Access Compliance Report

Public Rights-of-Way

Intersection ID: 17457	Main Street: S_WENDOVER_RD	Cross Street: VERNON_DR	Location: S
ADA ID: 3B892F47EAF5	Ramp Type: PerpDiag	Initial Pass/Fail: Fail	Overall Compliance: No
Codes/Mitigation Info/Possible Solution		Field Measurements/Component Compliance

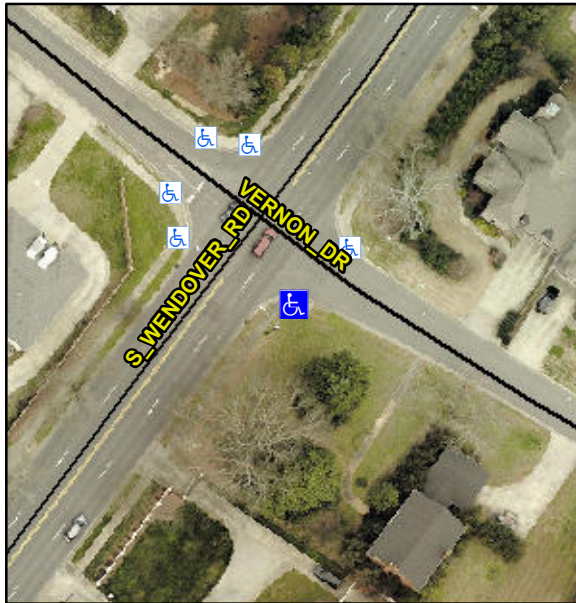
Not Found, R304.2.2, R304.5.3

Compliance	Description	Data	Compliance	Description	Data
N/A	Ramp Length (in)	88.0	No	Ramp Slope (%)	8.5
Yes	Ramp Width (in)	48.0	No	Ramp XSlope (%)	3.8
N/A	Flare Type LT	N/A	N/A	Flare Type RT	N/A
N/A	Flare Slope LT (%)	N/A	N/A	Flare Slope RT (%)	N/A
N/A	Flare Traversable LT?	N/A	N/A	Flare Traversable RT?	N/A
N/A	Landing Length (in)	N/A	N/A	DWS Provided?	N/A
N/A	Landing Width (in)	N/A	N/A	DWS Contrast?	N/A
N/A	Landing Slope (%)	N/A	N/A	DWS Length (in)	N/A
N/A	Landing X Slope (%)	N/A	N/A	DWS Full Width?	N/A
N/A	Landing Curb? (Y/N)	N/A	N/A	DWS Offset (in)	N/A
N/A	Shared Landing?	N/A			
N/A	Gutter Ponding?	N/A	N/A	Gutter Slope (%)	N/A
N/A	Gutter Lip Ht (in)	N/A	N/A	Gutter X Slope (%)	N/A
N/A	Painted X Walk1?	No	N/A	Painted X Walk2?	No
	X Walk 1 Direction	To NE		X Walk 2 Direction	To NW
N/A	X Walk 1 Width (in)	N/A	N/A	X Walk 2 Width (in)	N/A
	X Walk 1 Slope (%)	1.7		X Walk 2 Slope (%)	2.9
	X Walk 1 X Slope (%)	4.9		X Walk 2 X Slope (%)	1.7

Remove & Replace Curb Ramp With Two New Directional Ramps or Equivalent.
